The Lake Lothing (Lowestoft) Third Crossing Order 201[*]

**Document 7.5:
Design Report**

**LAKE LOTHING THIRD
CROSSING, LOWESTOFT**
ROAD SAFETY AUDIT STAGE 1

FINAL ISSUE REPORT
PROJECT NO: 1069948-WSP-HAC-LL-RP-ZS-0002

5.1 SOUTHERN ROUNDABOUT

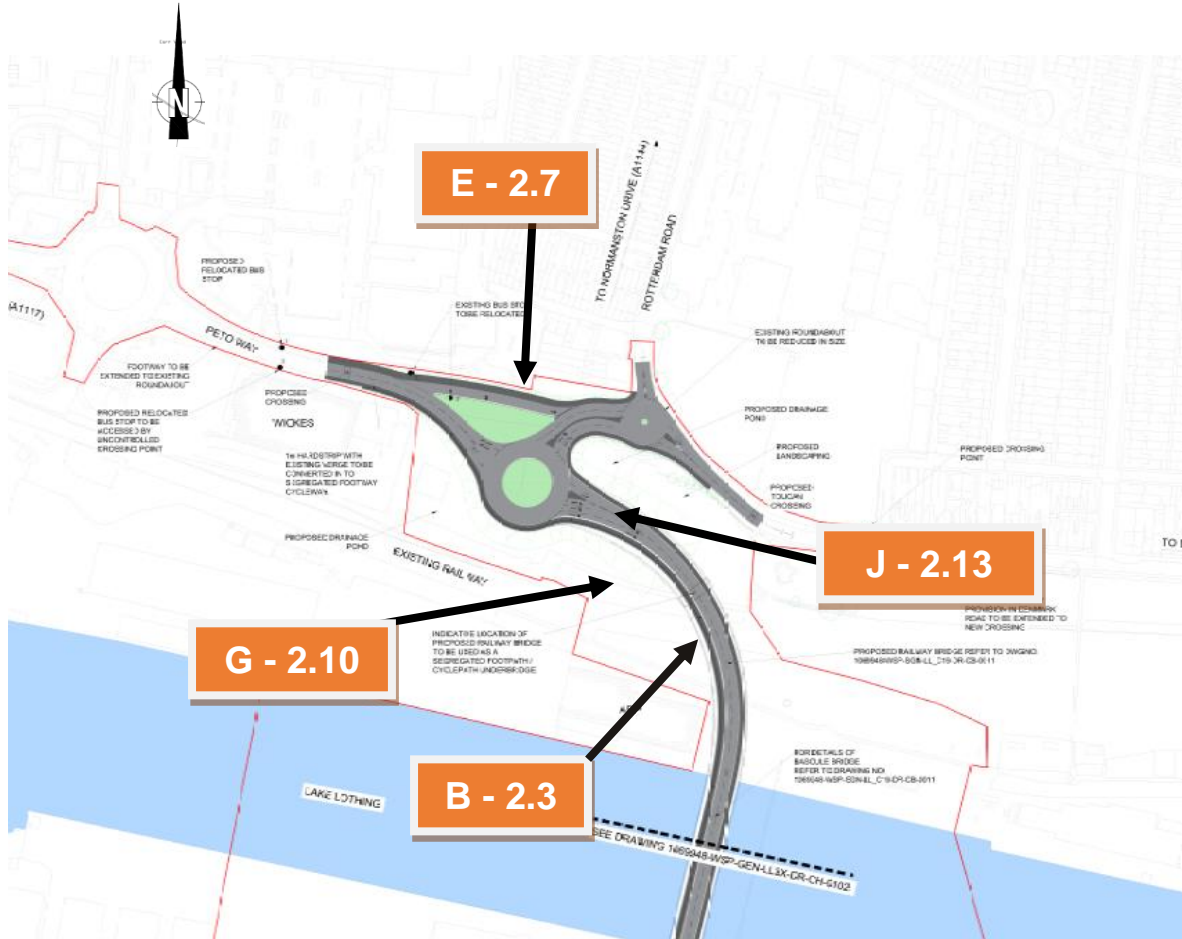
Location: A – Waveney Drive / Riverside Road ghost-Island junction

Summary: The proposed priority ghost-island junction layout between Waveney Drive and Riverside Road will replace a controlled junction layout serving a major employment areas. Providing a priority junction layout could create long delays for drivers on Riverside Road resulting them becoming frustrated and impatient leading to risk taking at the junction area with collisions occurring.

Location: C – Access to Motorlings from Waveney Drive.

Summary: The proposed access to the Motorlings area is unlikely to accommodate a car-transported vehicle when delivering / collecting cars from the Motorlings premises. This will result in a large vehicle creating a hazard on Waveney Drive on the immediate exit from the proposed roundabout leading to likelihood of collisions occurring.

Location: D – Layout of side road junction with Waveney Drive.

Summary: The proposed vehicle access, adjacent to that provided for Motorlings area, is unlikely to accommodate the geometry to accommodate a turning vehicle to accomplish the left-turn on the Waveney Drive. This may result in a vehicle over-running the shared-use footway conflicting with footway users.

Location F – Southern Roundabout

Summary: The existing four arm traffic signalised junction at Waveney Drive provides a pedestrian controlled crossing facility on all four arms. The proposed roundabout indicates that uncontrolled crossings will be provided. There is a high risk of a pedestrian being in collision with a vehicle at the proposed uncontrolled crossing points when attempting to cross the road.

Location G – Shared-use route on northern side of Waveney Drive.

Summary: The existing shared-use route for pedestrians and cyclists is indicated to be used for carriageway access. This may create a conflict between vehicles and pedestrians / cyclists.

Location H – Southern Roundabout

Summary: The proposed shared-use route on the western side of the new link road from the southern roundabout does not provide connectivity for cyclists linking to the realigned Riverside Road. Cyclists will use the Waveney Drive northern footway which is not designated for shared-use, creating conflict with pedestrians.

Location J – Northern and Southern Roundabouts.

Summary: The road marking indicate that on one arm three traffic lanes are being provided whilst the proposed layout indicates that there is a maximum of two exit lanes which could result in side impact collisions.

2.2	Yes	Yes	The design life of the junction is currently not known. The whole of the adjacent site is the subject of a future development containing a mixture of residential and industrial development. The current junction is the preferred layout, as a signalised junction would result in private residences being 'caught in between' the signal heads, with a potential safety issue for turning vehicles into and out of private property. Provision of a roundabout is considered to be premature in light of the future development	Yes

2.4	Yes	Yes	The car transporter shall pull off Waveney Drive onto the hard standing between Waveney Drive and Kirkley Ham in a westerly direction. It shall then access the Tom Crisp Way roundabout through the existing Asda delivery yard entrance. The proposed island at the entrance to Motorlings shall comprise a 'solid white' painted island that can be overrun by vehicles particularly	Yes

2.6	Yes	Yes	The proposed access to Motorlings has been tracked for a car and small van entering and exiting and does not overrun the footway.	Yes
2.7	Yes	Yes	Vehicles travelling eastbound will have to slow down to enter the dedicated left lane to Rotterdam Road. Speeds will be low and appropriate signage will be provided as part of the detailed design to advise drivers of the second roundabout and the need to 'give way' as part of the detailed design.	Yes

2.9	Yes	Yes	Discussions on the type and location of crossings at Waveney Drive will be held as part of the detailed design process.	Yes
2.10	Yes	Yes	An access to Motorlings has to be provided as part of the works. This location is perceived as the best location. Conflicts with pedestrians and cyclists are to be kept to a minimum and appropriate signing and markings will be provided as part of the detailed design.	Yes

2.11	Yes	Yes	Links from the bridge to Riverside Road for cyclists and pedestrians are currently being investigated and will become part of the detailed design. The current preferred solution is to provide a	Yes
